CITY PLAN COMMISSION

FILE NUMBER: S234-094 SENIOR PLANNER: Sharmila Shrestha

REQUEST: An application to replat a 7.193-acre tract of land containing all of Lots 1 and 2 in City Block B/6357 and part of City Block 6357 to create one lot on property located on Pleasant Drive, northeast of C.F. Hawn Freeway/ US Highway No.175.

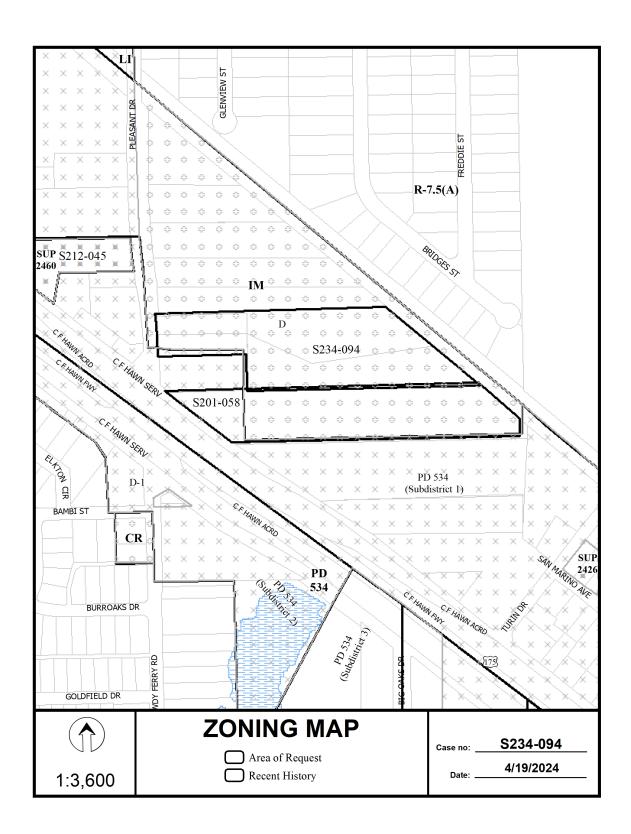
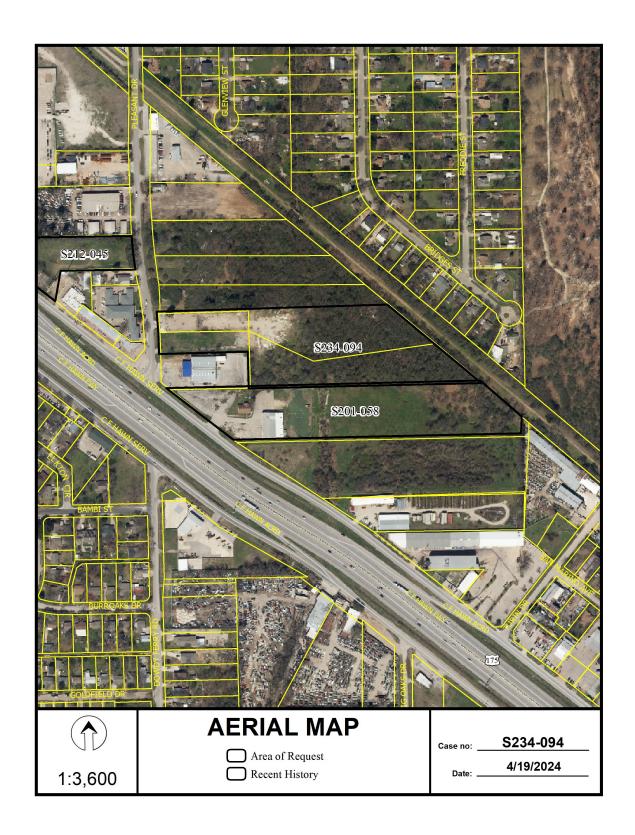
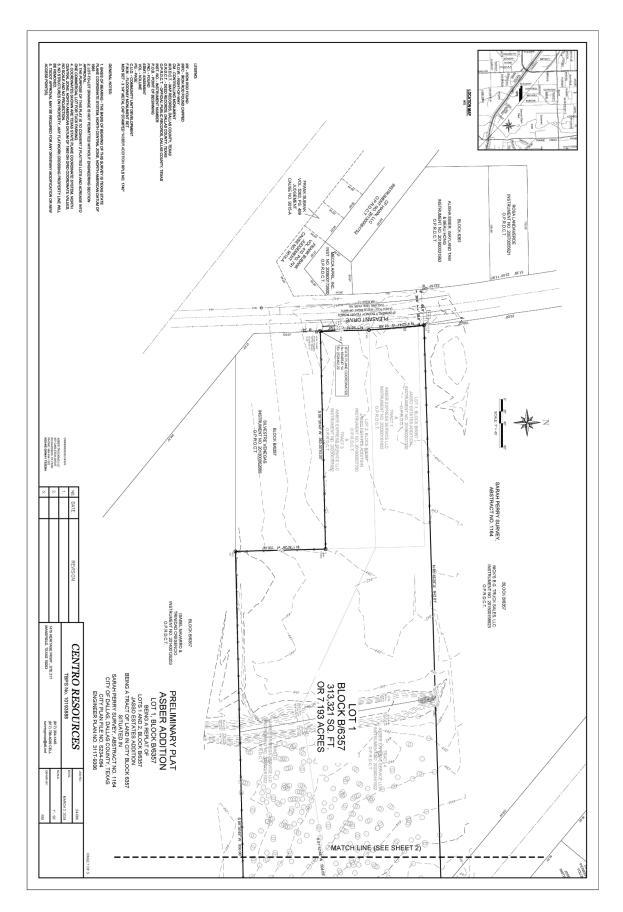
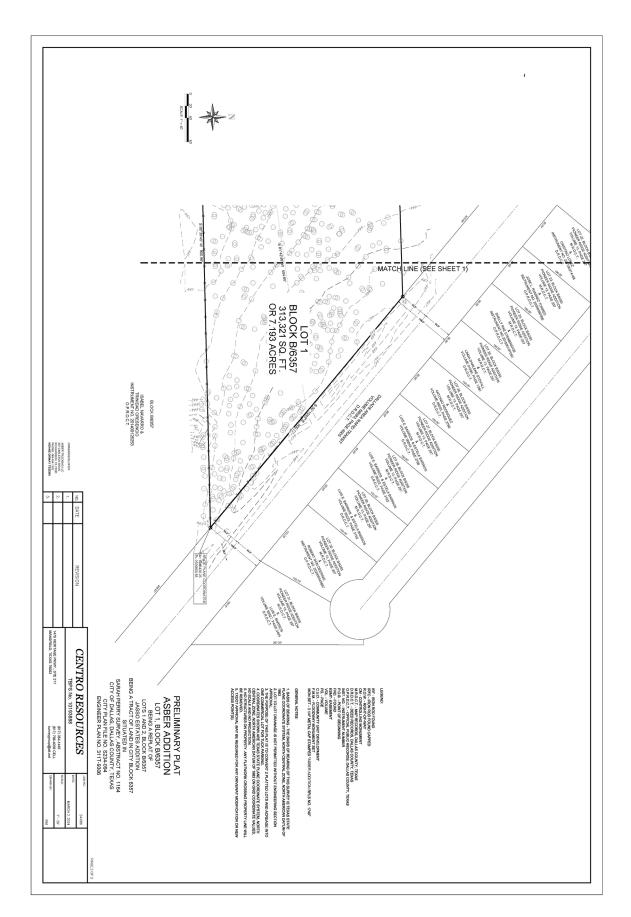
- 15. Existing drainage conveyance within the property is required to be sized in compliance with Section 51A-8.611(a)(1) of the City of Dallas Code.
- 16. Must coordinate with Dallas Water Utility-Floodplain regarding the existing Pruitt Branch within the property. Contact David Phan with Dallas Water Utility-Floodplain. Section 51A-8.611(a)(1)

- 17. Prior to final plat, submit a completed final plat checklist and all supporting documents.
- 18. On the final plat, show recording information on all existing easements within 150 feet of the property.
- 19. On the final plat, show all additions or tracts of land within 150 feet of the property with recording information.

20. Additional design information is required for assessment. Site plan must be submitted showing proposed development, building finished floor elevation, development, existing mains – including downstream manhole, and proposed

- water and wastewater service locations. Submit water/wastewater engineering plans to 320 E. Jefferson Blvd., Room 200, Attention: Water and Wastewater Engineering.
- 21. Water main improvements may be required by Private Development Contract. Submit water/wastewater Engineering Plans to 320 E. Jefferson Blvd., Room 200, Attention: Water and Wastewater Engineering.

- 22. On the final plat, add "C.F. Hawn Freeway/ U.S. Highway No. 175 (FKA Second Avenue FKA Kaufman Road)".
- 23. On the final plat, identify the property as Lot 1A in City Block B/6357.
